**From:** Neil Duffield [neil.duffield@bhdpartnership.com]  
**Sent:** 05 March 2009 13:52  
**To:** Hilary Saunders  
**Subject:** Middlerigg Farm Sneatonthorpe

**Re: Middle Rigg Farm, Sneatonthorpe**

DISCIPLINE: ARCHITECTURAL  
 CLIENT: MR K. HOWARD  
 PROJECT: MIDDLE RIGG FARM STAINSACRE LANE, STAINSACRE  
 TITLE: ALTERATIONS OF FARM HOUSE (A) PROPOSED ELEVATIONS & SECTION A-A

DISCIPLINE: ARCHITECTURAL  
 CLIENT: MR K. HOWARD  
 PROJECT: MIDDLERIGG FARM  
 STAINSACRE LANE, STAINSACRE  
 TITLE: ALTERATIONS OF OUTBUILDING B  
 PROPOSED PLANS  
 & ELEVATIONS

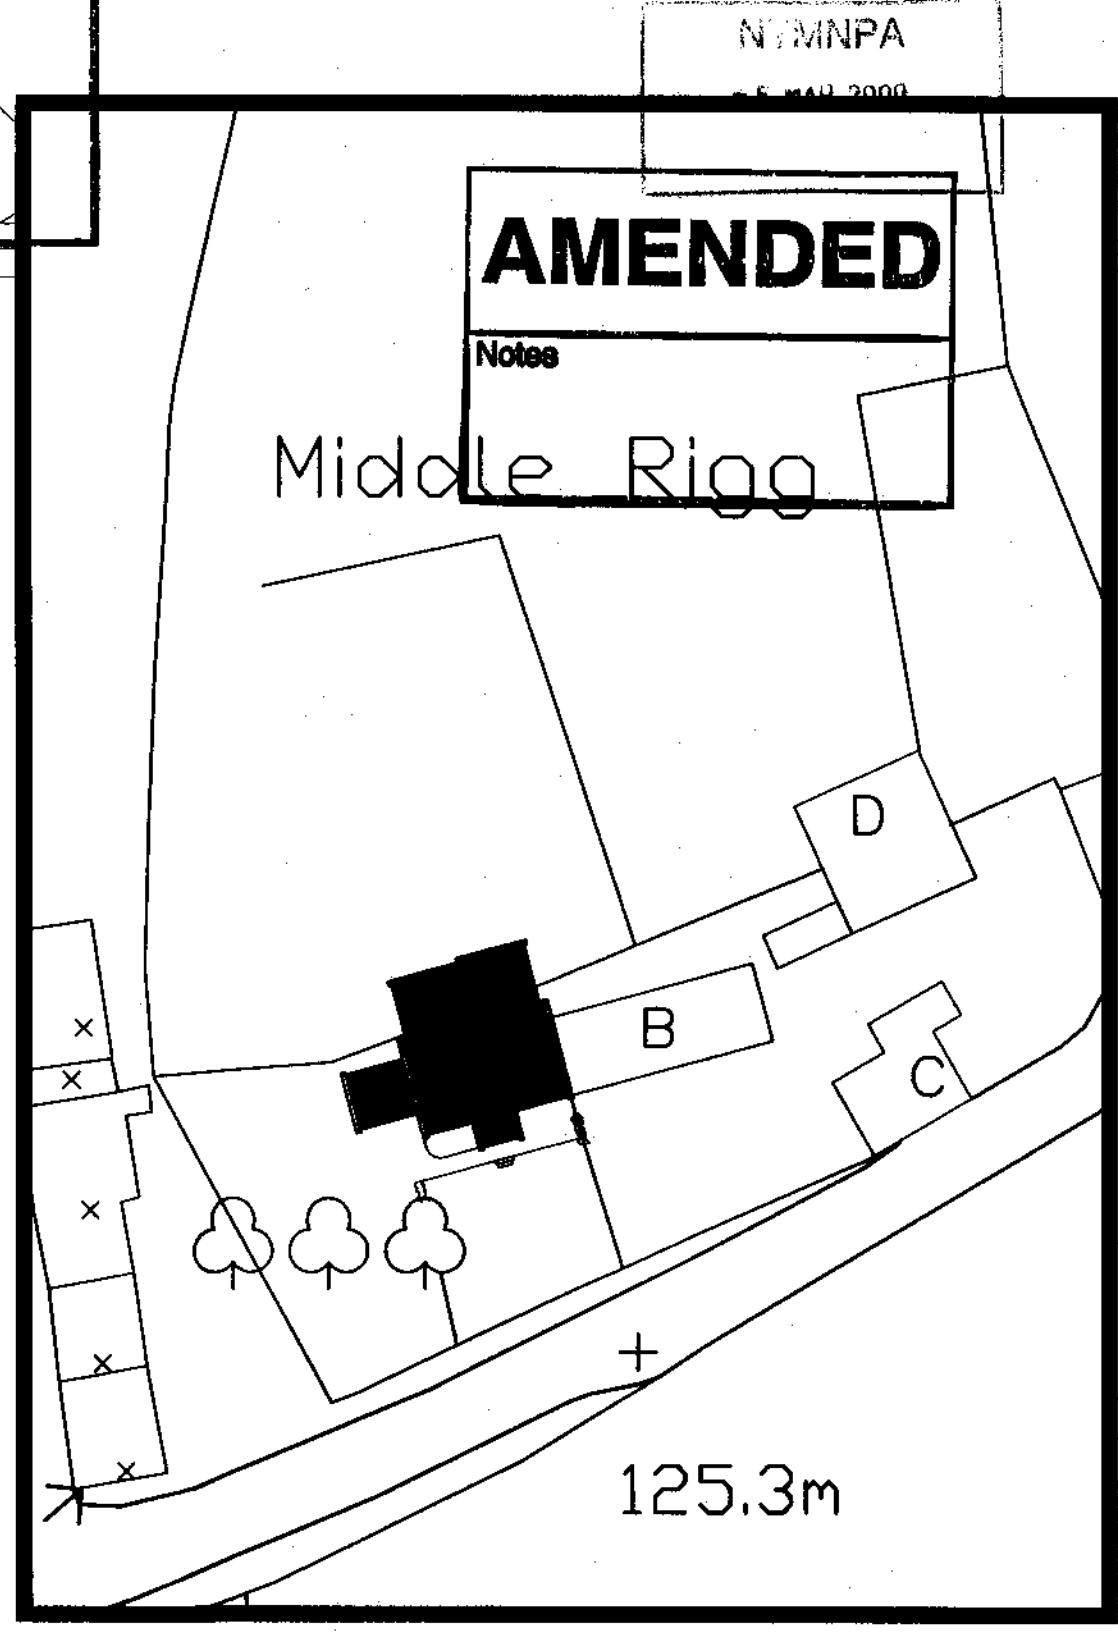
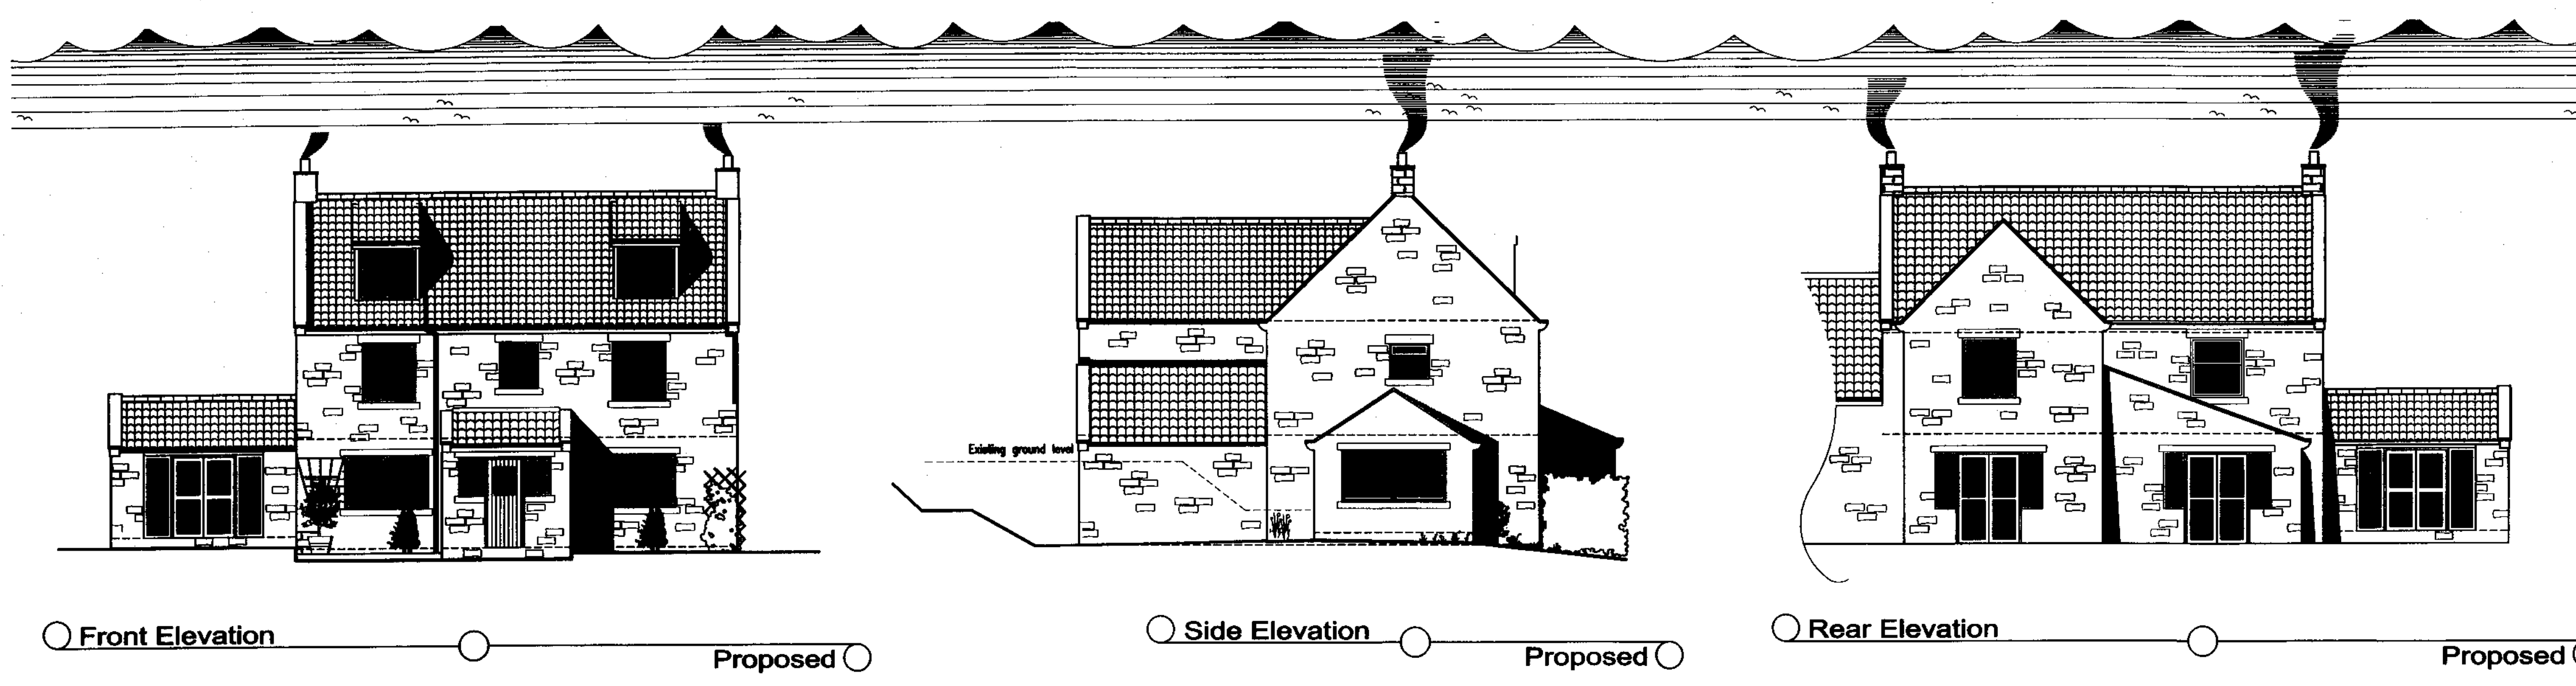
REV	DATE	BY	AMENDMENT	CHKD	APPD
C	04/03/09	KH	ROOFLIGHTS OMITTED		
B	03/10/07	GR	ROOF LOWERED TO ORIGINAL HEIGHT	KSH	
A	09/05/06	CSB	ISSUED FOR CLIENT COMMENT	NID

TITLE: ALTERATIONS OF FARM HOUSE (A)  
PROPOSED ELEVATIONS  
& SECTION A-A

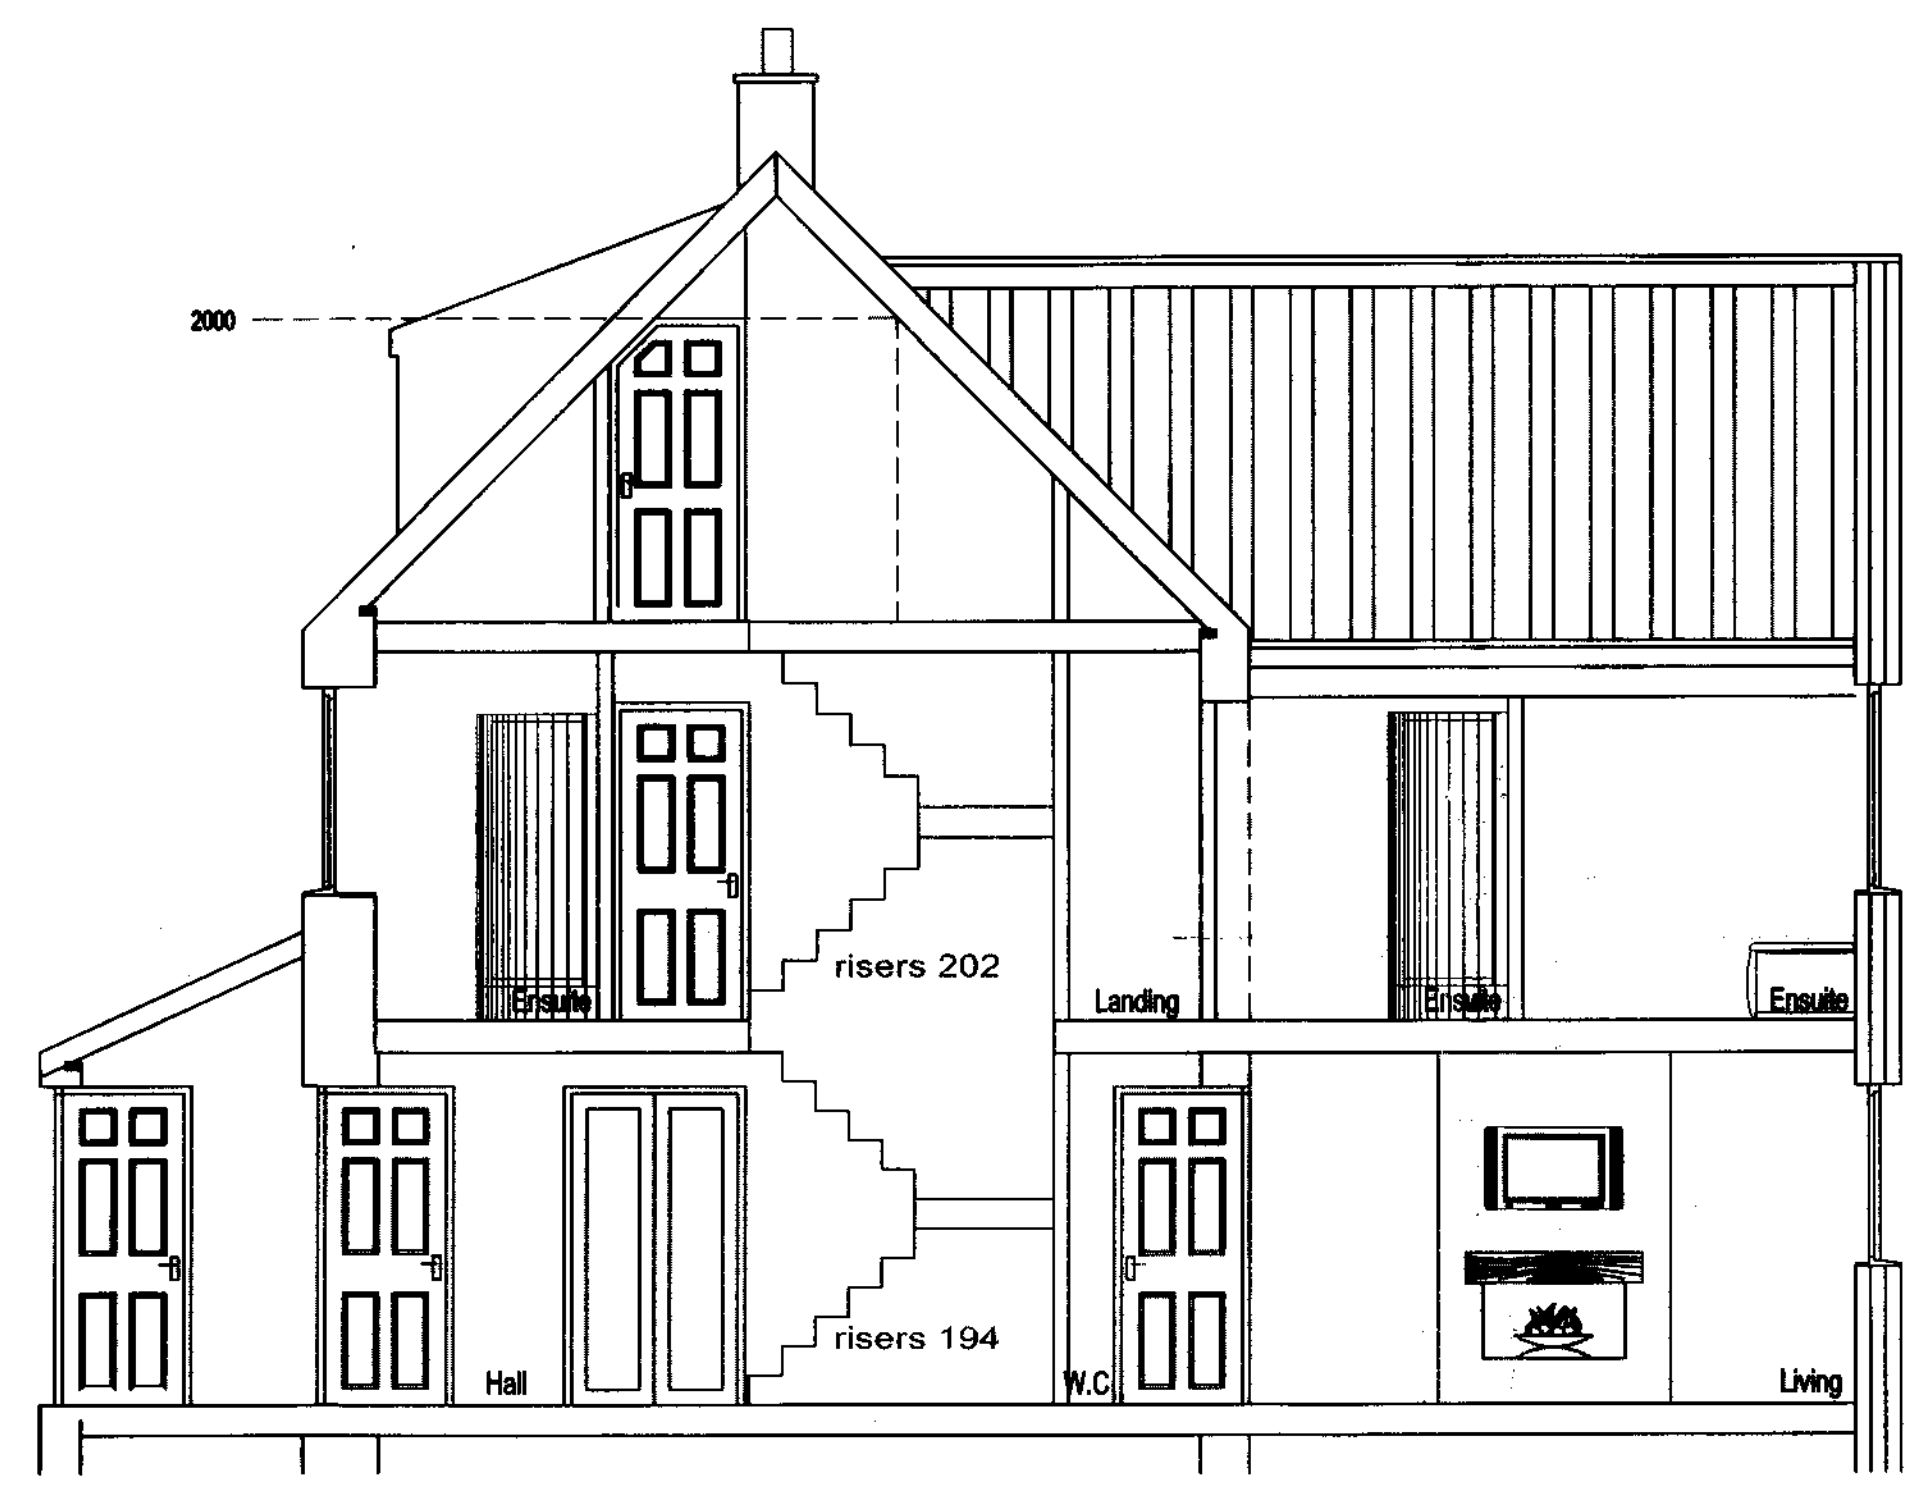
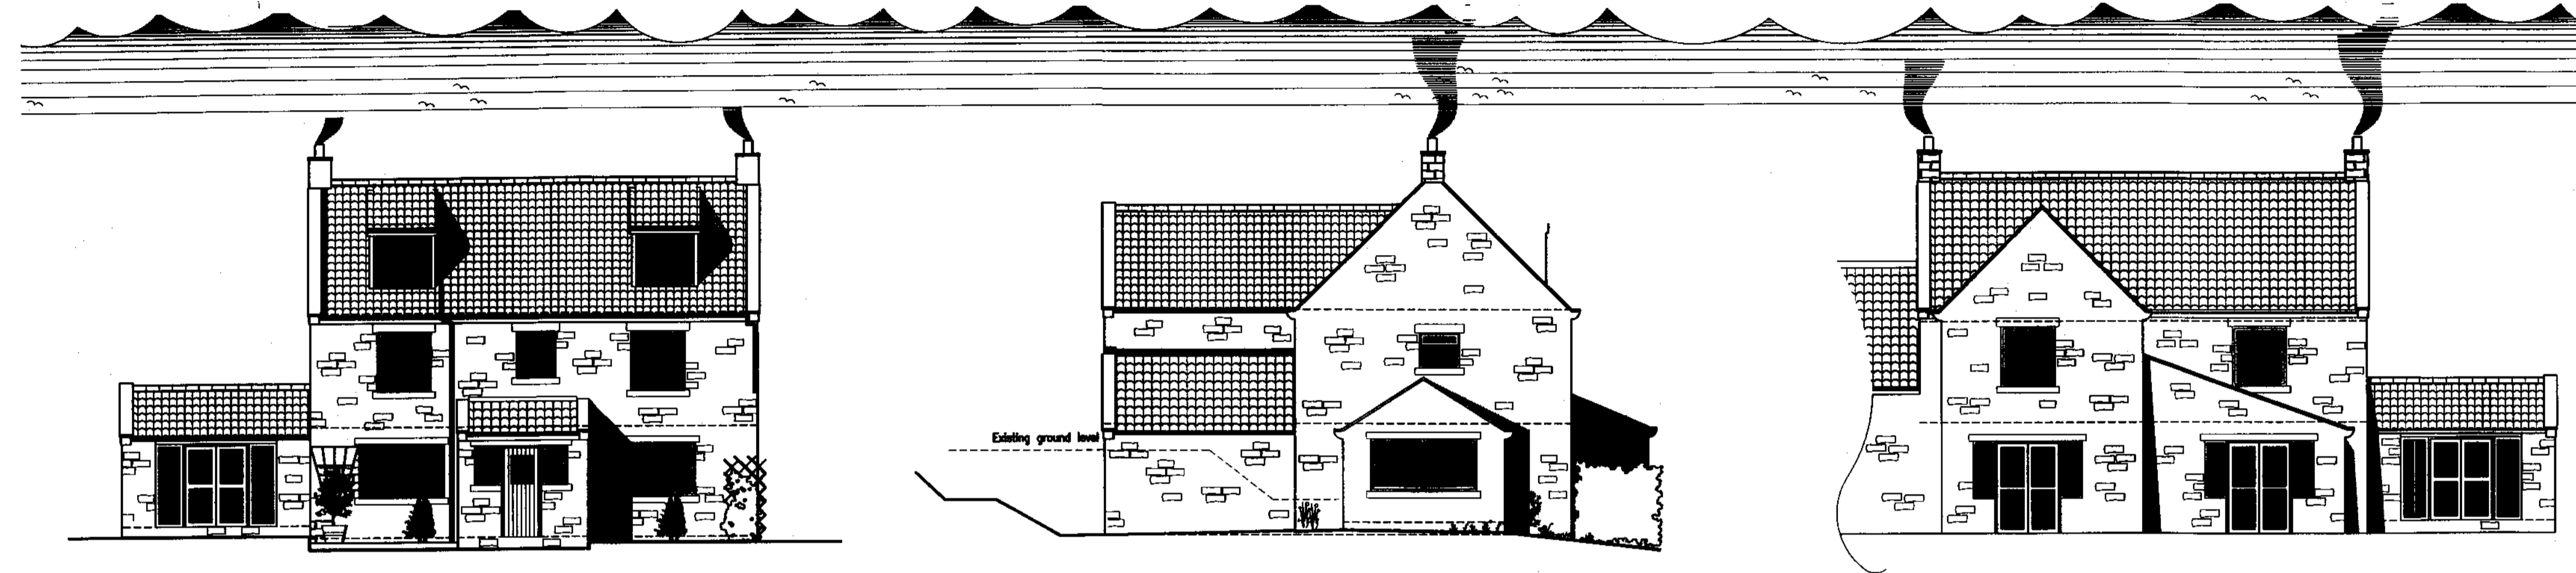
REV	DATE	BY	AMENDMENT	CHKD	APPD
C	04/03/09	KH	ROOF HEIGHT REDUCED		
B	03/10/07	GR	REVISED TO SUIT PLANNERS	KSH	
A	09/05/06	CSB	ISSUED FOR CLIENT COMMENT	NID
